Date: 1/8/2021
Project: University of New Mexico Hospitals - New Hospital Tower
2211 Lomas Blvd NE
Albuquerque, NM 87106

Bid Package: Phase I - Make Ready
ASI #: 04 (REVISED)

SCOPE OF WORK FOR ASI #4 IS INCLUSIVE OF ITEMS SHOWN ON THIS SHEET THAT ARE RELATED TO BLUE PHONE ONLY

Sheet Number
TS100

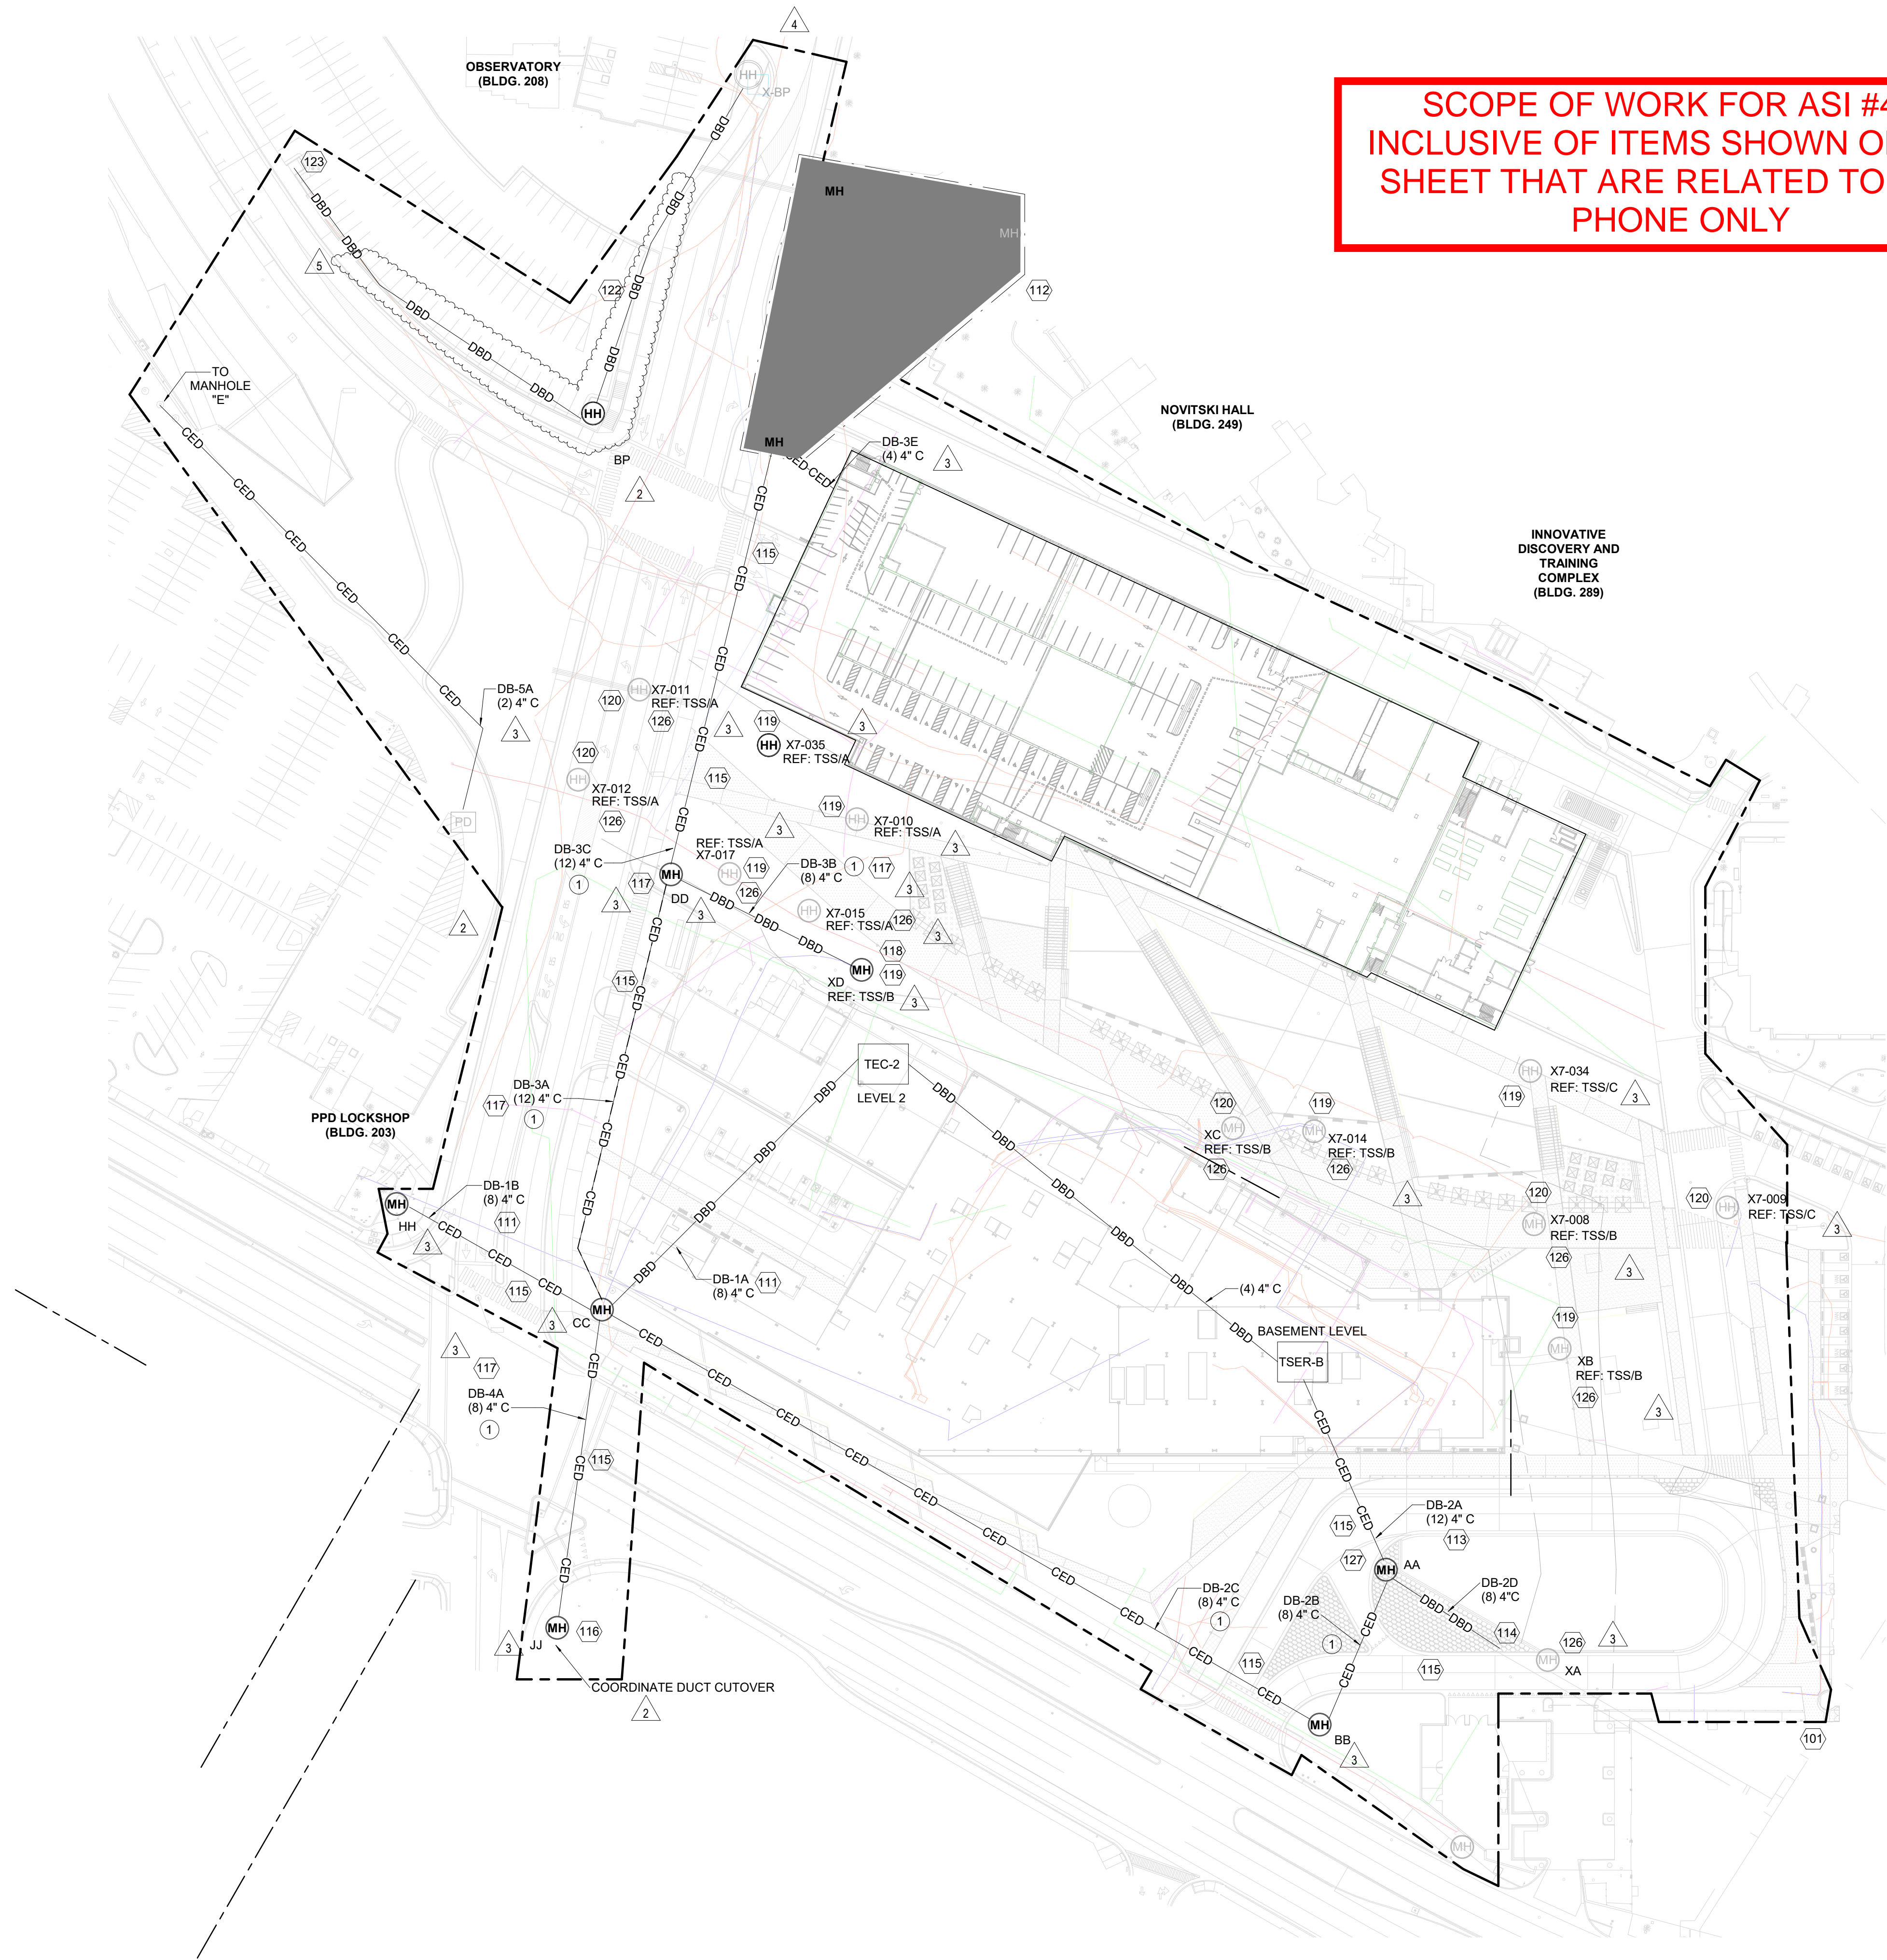
SCOPE OF WORK FOR ASI #4 IS
INCLUSIVE OF ITEMS SHOWN ON THIS
SHEET THAT ARE RELATED TO BLUE
PHONE ONLY

- BLUE PHONE RELOCATION PATHWAY: INTERCEPT EXISTING COMMUNICATION CONDUITS STRUBBED TO THE NORTH END OF THIS PARKING LOT IN PHASE I. NEW CONDUITS SHALL MATCH EXISTING (SIZE AND TYPE). PROVIDE CABLEING SIMILAR TO EXISTING AND EXTEND NEW CABLEING TO BLUE PHONE LOCATION. SLICE CABLE IN ACCORDANCE WITH SPECIFICATION WITHIN EXISTING HANDHOLE DEVICE.

- BLUE PHONE LOCATIONS: NEW LOCATION OF EXISTING BLUE PHONE (DEMOTED) WITHIN PHASE I). COORDINATE CONDUIT PATHWAY ROUTING WITHIN BLUE PHONE BASE AND TERMINATE CONDUIT AND CABLE WITHIN BLUE PHONE DEVICE AS REQUIRED.
